CAMECO RESOURCES
CROW BUTTE OPERATION

Subject: 2008 Annual Pond Inspection Report
Source Materials License SUA-1534
Docket Number 40-8943

2008 POND INSPECTION REPORT

By: David V. Coe, PE
Nebraska Registration No. E - 4295

#11 North view of west embankment & berm of pond #1, good protection against erosion of berm & protection of area adjacent to pond liner. 10/20/08

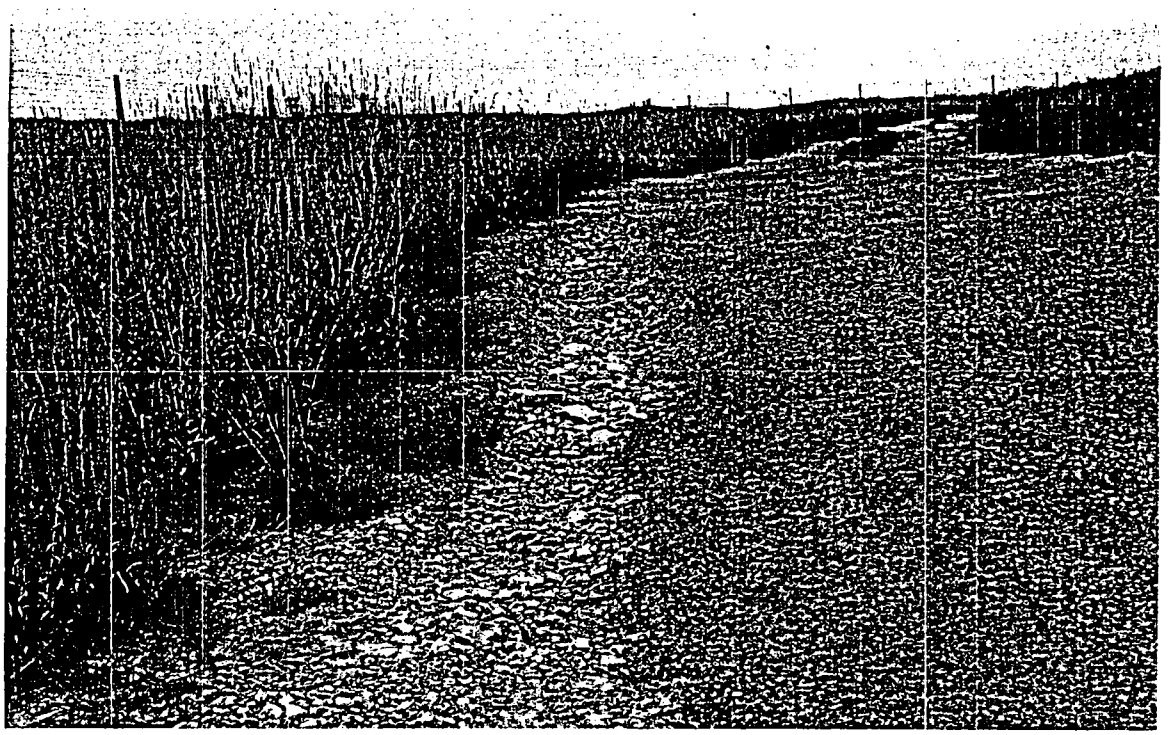
The vegetation along the west embankment of pond #1 looks very good.
